Access Compliance Report

Public Rights-of-Way

Intersection ID: 49696	Main Street: MADISON HILL CT	Cross Street: THISTLE FIELD LN	Location: SE
ADA ID: 308A2193CB6E	Ramp Type: Perp	Initial Pass/Fail: Pass	Overall Compliance: No
Severity Score: 0			
Codes/Mitigation Info/Possible Solution		Field Measurements/Component Compliance

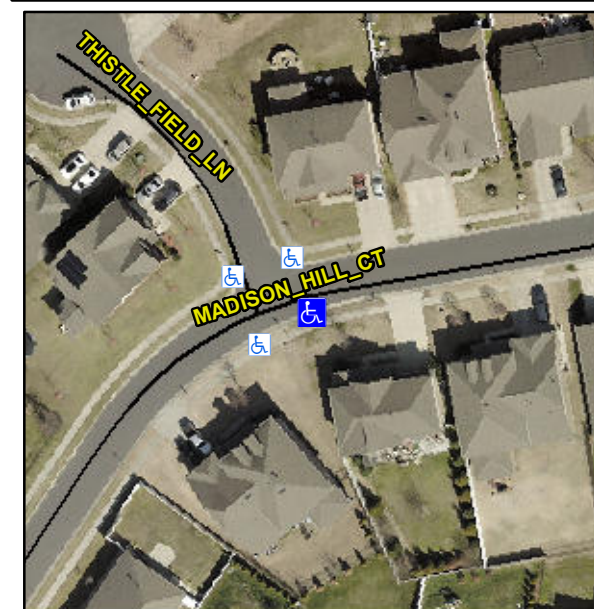
Not Found, R304.2.2-Perp, R304.3.2-Para, R305.2

Compliance	Description	Data	Compliance	Description	Data
N/A	Ramp Length (in)	47.5	Yes	Ramp Slope (%)	7.0
Yes	Ramp Width (in)	48.0	Yes	Ramp XSlope (%)	0.8
N/A	Flare Type LT	Sloped	N/A	Flare Type RT	N/A
N/A	Flare Slope LT (%)	3.6	Yes	Flare Slope RT (%)	3.0
N/A	Flare Traversable LT?	Yes	N/A	Flare Traversable RT?	Yes
Yes	Landing Length (in)	48.0	Yes	DWS Provided?	Yes
Yes	Landing Width (in)	48.0	Yes	DWS Contrast?	Yes
No	Landing Slope (%)	2.1	Yes	DWS Length (in)	24.0
Yes	Landing X Slope (%)	1.4	Yes	DWS Full Width?	Yes
N/A	Landing Curb? (Y/N)	No	No	DWS Offset (in)	3.0
N/A	Shared Landing?	No			
Yes	Gutter Ponding?	No	Yes	Gutter Slope (%)	0.0
Yes	Gutter Lip Ht (in)	0.0	Yes	Gutter X Slope (%)	0.9
N/A	Painted X Walk1?	No	N/A	Painted X Walk2?	N/A
	X Walk 1 Direction	To NW		X Walk 2 Direction	N/A
N/A	X Walk 1 Width (in)	N/A	N/A	X Walk 2 Width (in)	N/A
	X Walk 1 Slope (%)	2.3		X Walk 2 Slope (%)	N/A
	X Walk 1 X Slope (%)	0.6		X Walk 2 X Slope (%)	N/A

Remove & Replace Entire Ramp.
